Seamless Reduncancy Issues Supporting comments on P802.1CB Draft 2.0

Norman Flnn Editor, P802.1CB

Ver. 2 October 22, 2015

The issue

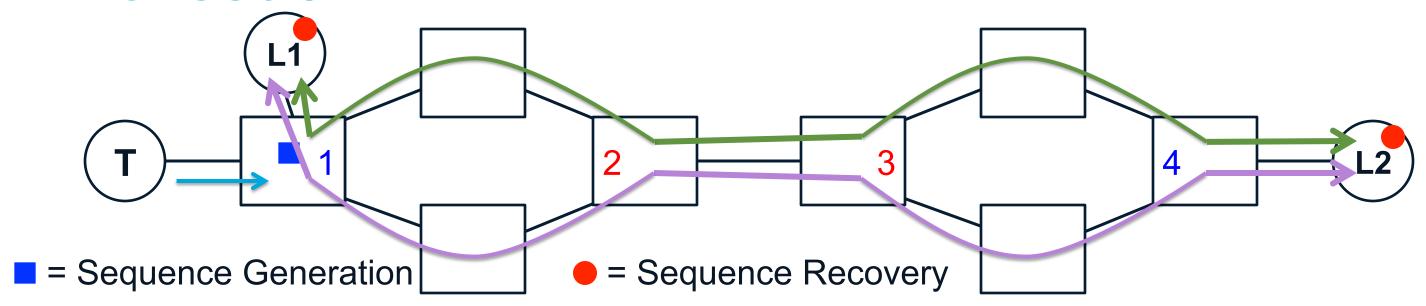
- Mixed scenario: Bridge 1 sequences and splits, both Listeners expect to merge and recover, and Bridges 2, 3, and 4 simply forward.
- SR is implemented in Bridge 1 and in both Listeners; most of the relay systems and the Talker are SR-unaware.
- Bridge 1 cannot be configured this way in P802.1CB Draft 2.0. (See editor's note, P802.1CB D2.0 p82 L26.)

Proposed resolution of Question 1: Allow multiple outputs from one input.

- Allowing this configuration requires replicating two copies of one input packet, perhaps identical, perhaps different, on the same output link.
- Editor recommends that this capability be required, and that the managed objects be altered to support it.
- Working Group conclusion:

Additive delays

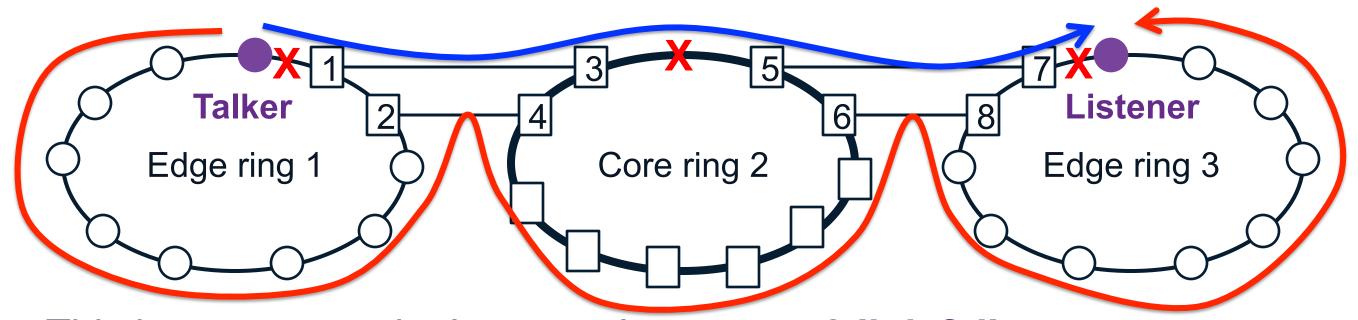
- This is a common deployment. It supports 3 link failures,
- The shortest path from Talker to Listener is the one along which the Listener usually receives its packets.
- The longest path is used, however, if the 3 link failures are exactly the ones shown.

Additive delays

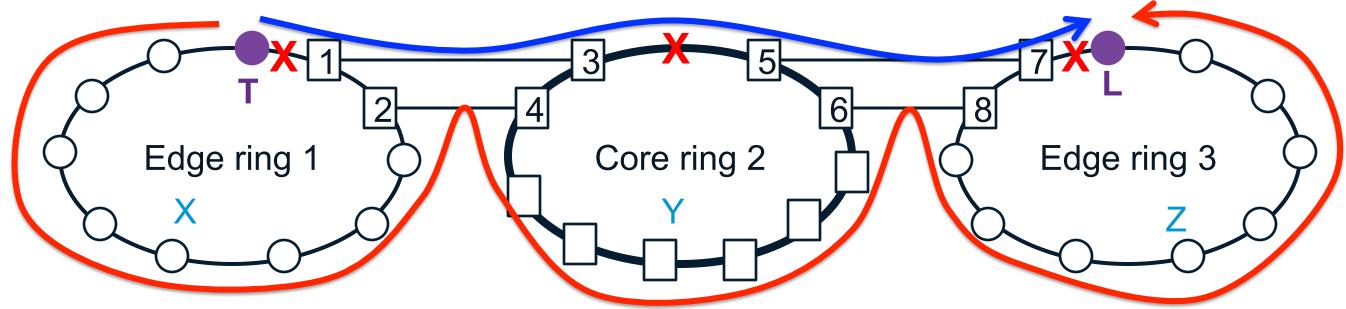
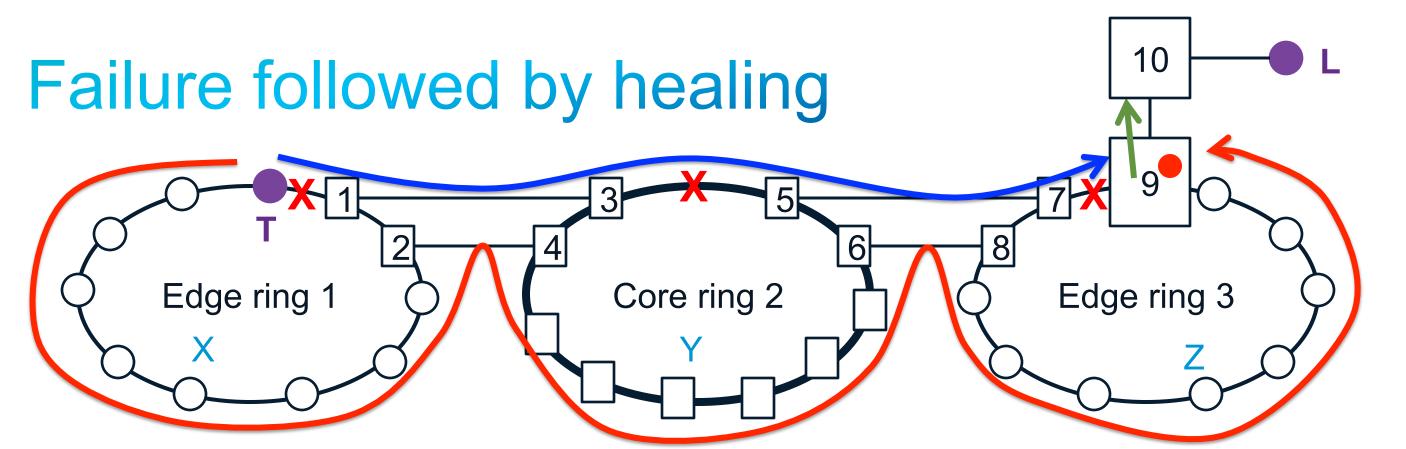
- $\Delta t_1 = t(TX2) t(T1)$, $\Delta t_2 = t(4Y6) t(35)$, $\Delta t_3 = t(8ZL) t(7L)$
- Total delta Talker to Listener $\Delta t_{TL} = \Delta t_1 + \Delta t_2 + \Delta t_3$
- This is nothing for intermittent Streams, but it is critical for bulk Streams.

- Let us look at what happens if all three links fail, and then heal, each at the same time. Note that we have added Bridge 9, which performs sequence recovery and sends a single TSN Stream to the Listener via Bridge 10.
- (This is not a silly scenario! Human-induced network management errors and the unfortunate placement of big electric motors are two causes.)
- Remember, we are looking at bulk Streams.

Proposed resolution of Question 2: Add Delay Function to P802.1CB

- If the given is that CQF distributes packets from input to output based on time, then the obvious solution is to introduce deliberate timed delay FIFOs at certain points in the network to equalize the path delays.
- One FIFO per group of Streams with the same path deltas is sufficient.
- These delay functions could be specified in P802.1Qch, in P802.1CB, or in some other 802.1Q amendment, but we can observe that:
 - The delay function is useful to both
 - bulk Streams and CQF Streams.
 - There is no need for a delay function if Seamless Redundancy is not employed.
 - Therefore, P802.1CB seems to be the right place for it.
- Working Group decision:
